VILLAGE OF ESTERO
PLANNING ZONING AND DESIGN BOARD MEETING
PACKET
JULY 21, 2026, 04:30 PM

- a. Leo Brown Group/Mission Grove of Estero, Plaza Del Sol, Parcel G -- East (Pending Application) (District 4) 10251 Arcos Avenue, north of Culver's and Auto Zone.**

a. Coconut Point Developers LLC -- Developer Repaint Project and Revised Signage Plan DCI2026-E001 (District 6)

KEYNOTES

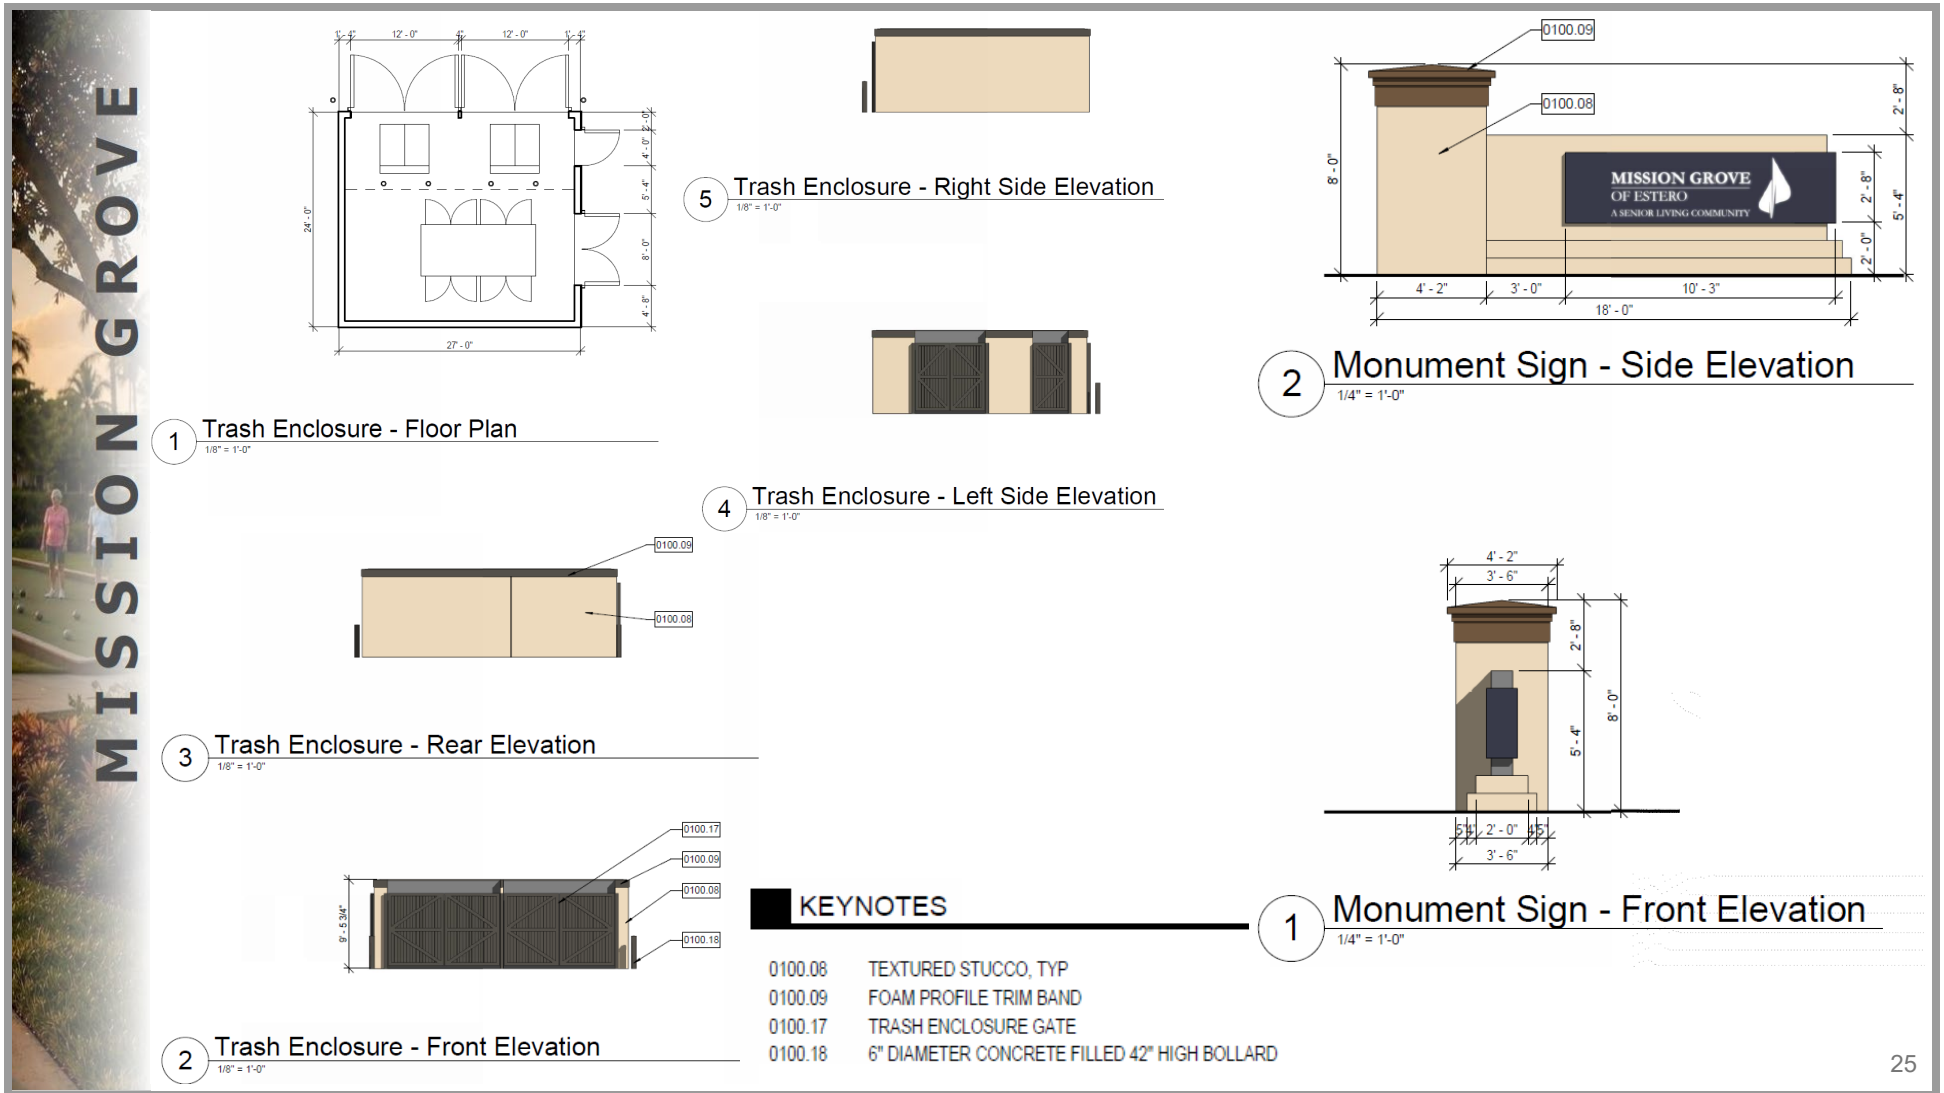
4:58:44PM PERHAPS MORE WORK IN DESIGN MIGHT BE HELPFUL TO GET
 GREATER
 4:58:49PM EXPRESSION, MORE SHADOW, MORE DETAIL, ET CETERA.
 4:58:52PM THE BUILDING IS RATHER PLAIN, RIGHT?
 4:58:55PM AND, OF COURSE, IN ESTERO, WE DON'T WANT BUILDINGS
 4:58:58PM PREDOMINANTLY ONE COLOR.
 4:59:00PM YOUR ELEVATIONS, THE WHOLE THING LOOKS BEIGE.
 4:59:03PM BEIGE ON BEIGE ON BEIGE, DIFFERENT SHADES.
 4:59:06PM AGAIN, THE RENDERINGS VERSUS THE ELEVATIONS I THINK THE
 4:59:11PM 3Ds ARE ALWAYS BETTER TO SHOW WHAT YOU'VE GOT.
 4:59:14PM OFTENTIMES THE ELEVATIONS JUST DON'T REALLY SHOW IT WELL.

5:00:30PM IT NEEDS A LITTLE MORE DETAIL AND NEEDS TO BE BROKEN UP A
 5:00:33PM LITTLE BIT MORE SO THAT IT'S MORE DISTINCTIVE PARTS OF THE
 5:00:36PM BUILDING RATHER THAN ONE BIG BLACK BUILDING.

5:03:31PM BREAKING THE EAVE LINE WITH LITTLE LARGER ELEMENTS.
 5:03:34PM LITTLE TALLER, BRINGING THE COLORS ALL THE WAY --
 5:03:40PM >>Jim Wallace: FOUR FEET INSTEAD OF TWO FEET.
 5:03:48PM >>Glen Baurhyte: ANOTHER ROOF LEVEL CHANGE KIND OF HIDDEN BY
 5:03:50PM A PALM TREE IN THIS VIEW.
 5:03:52PM >>Al Paivandy: THE OTHER CORNER HAS ALL OF THE ELEMENTS THAT
 5:03:56PM APPEARS TO BE EVERYBODY IS LOOKING FOR, THE VARIATION IN

5:05:26PM >>Glen Baurhyte: YES.
 5:05:28PM HAVEN'T HAD THE LANDSCAPE TEAM DO THEIR THING YET ON THIS.
 5:05:32PM I KNOW RIGHT HERE WAS SPACE FOR A SHADE STRUCTURE THAT THE
 5:05:36PM RENDER DIDN'T SHOW.
 5:05:37PM THE TREES ARE NOT FINAL.
 5:05:42PM >>Jim Wallace: THE NORTH AND SOUTH ELEVATION HAVE MUCH MORE
 5:05:46PM INTEREST.
 5:05:49PM WHEN YOU GET TO THE WEST, IT LOOKS LIKE PRISON.

LANDSCAPE ARCHITECT

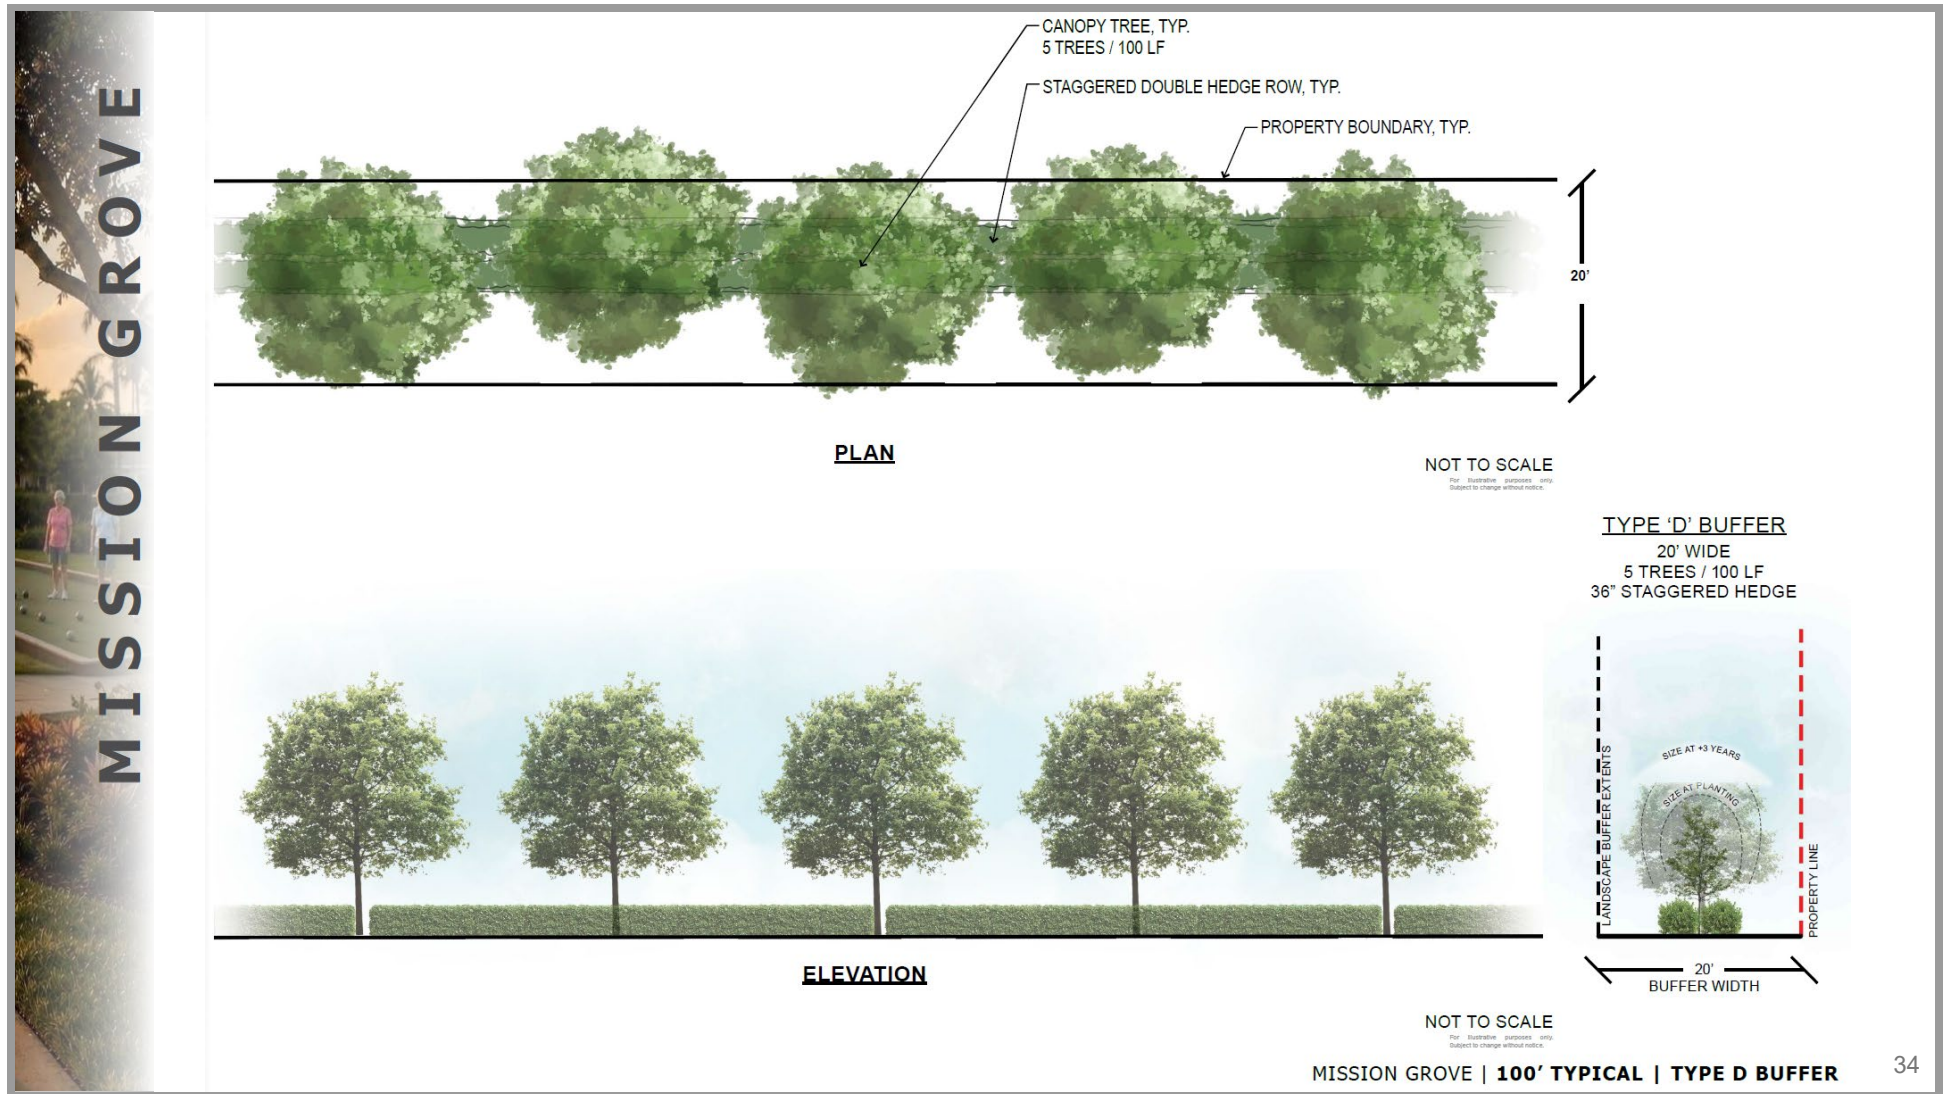
5:19:03PM IT APPEARS TO ME THAT THE RENDERINGS HAVE ABOUT 50%, 60%
 5:19:08PM MORE TREES THAN THE PLAN.
 5:19:14PM I'M PRESUMING THAT THE RENDERINGS ARE CORRECT AND YOU'LL BE

5:20:25PM PARTICULARLY WORKING WITH THE ARCHITECT TO CREATE -- SO IT
 5:20:31PM ISN'T JUST ONE BIG BLANK WALL.
 5:20:34PM HERE WE HAVE THREE TREES.
 5:20:35PM IT'S A BIG BUILDING FOR THREE TREES, SABRINA.
 5:20:40PM I'M SURE YOU'RE -- I'VE GOT TO BELIEVE YOU WILL ADD A LOT
 5:20:48PM MORE TREES.
 5:20:49PM >>Sabrina McCabe: WE WILL.
 5:20:50PM FROM THE STREET VIEW YOU'LL SEE AN ENTIRE RIGHT-OF-WAY
 5:20:53PM BUFFER, PLUS THE PARKING LOT TREE, PLUS THOSE THREE TREES.
 5:20:57PM YOU'RE NOT SEEING THE DETAIL IN THE PLANTERS RIGHT UP

5:22:10PM HAVING SAID THAT I ASSUME THE DOTTED LINES SHOWN ON THERE
 5:22:14PM ARE THE WALKWAYS.
 5:22:15PM >>Sabrina McCabe: YES.
 5:22:16PM >>Al Paivandy: I WOULD LIKE TO RECOMMEND, IF POSSIBLE, TO
 5:22:20PM PROVIDE A LOT MORE SHADE TREES IN THOSE AREAS.

5:22:39PM HAVING WALKED IN A LONG LINE, YOU MAY WANT TO PROVIDE A LOT
 5:22:45PM MORE TREES FOR THEM TO BE ABLE TO BE IN THE SHADE ESPECIALLY
 5:22:51PM WITH THE MEMORY CARE.

5:19:17PM ADDING A LOT MORE TREES TO THE PLAN.
 5:19:19PM >>Sabrina McCabe: AS GLEN MENTIONED, THEY SHOW THE PALMS
 AND
 5:19:22PM THINGS TO HELP WITH THE SCALE.

5:19:24PM WE ARE CONTINUING ESPECIALLY WHAT WE HAVE SHOWN YOU IN
 PLAN
 5:19:27PM VIEW IS A LOT FOCUSED ON THE BUFFER AREAS AND OVERALL
 COMMON
 5:19:30PM AREAS OF THE SITE.

5:21:00PM AGAINST THE BUILDING WHERE WE'LL HAVE MORE OF THE LAYERS.
 5:21:03PM WE WILL DO OUR BEST --
 5:21:05PM >>Jim Wallace: THEY ARE JUST NOT SHOWN HERE.
 5:21:07PM >>Sabrina McCabe: CORRECT.
 5:21:08PM WE ARE GOING TO CONTINUE --
 5:21:11PM >>Jim Wallace: IT'S A TALL BUILDING.
 5:21:13PM SHRUBS ARE NICE, THEY ARE NICE AS UNDERPLANTINGS TO TALL
 5:21:17PM TREES.
 5:21:17PM >>Sabrina McCabe: AGREED.
 5:21:18PM THAT'S WHAT IS SHOWN IN THE RENDERING.
 5:21:20PM WE'LL MAKE SURE THAT WE ARE COORDINATED WHEN WE COME

5:23:15PM OFTEN.
 5:23:15PM WE'LL MAKE SURE WE PROVIDE THOSE CANOPY TREES AS WELL AS
 5:23:18PM ACCENTS AND THINGS THAT GIVES THEM HEIGHT TO COMPLEMENT
 THE

5:23:35PM AND WE'LL DEFINITELY RELOOK AND DO OUR BEST TO PROVIDE AS
 5:23:40PM MUCH SHADE AS POSSIBLE.
 5:23:42PM >>Al Paivandy: IT APPEARS THEY HAVE TRIED TO GET ALL THE
